# Access Compliance Report

## Public Rights-of-Way

### (Curb Ramps)

| Intersection ID: 13086 | Main Street: CENTRAL_AV | Cross Street: CLEMENT_AV | Location: NE           |

| ADA ID: 2CD5B61209A1   | Ramp Type: Perp         | Initial Pass/Fail: Fail  | Overall Compliance: No |

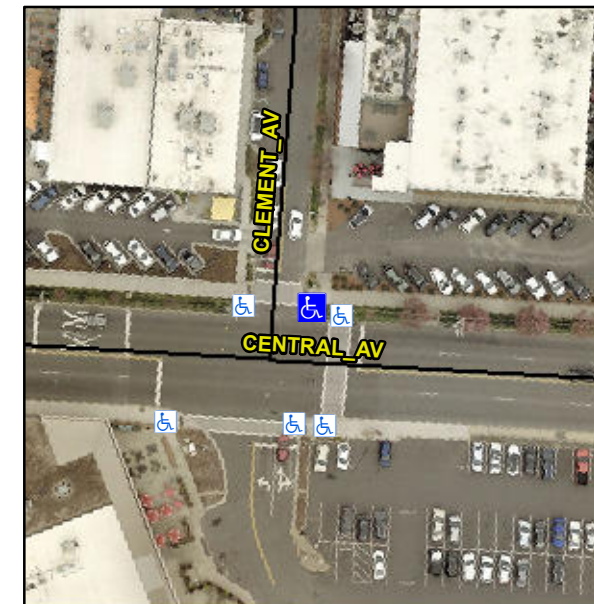
**R304.2.2**

| Compliance | Description           | Data  | Compliance | Description                 | Data |
|------------|-----------------------|-------|------------|-----------------------------|------|
| N/A        | Ramp Length (in)      | 99.0  | No         | Ramp Slope (%)              | 9.9  |

**Remove & Replace Entire Ramp.**
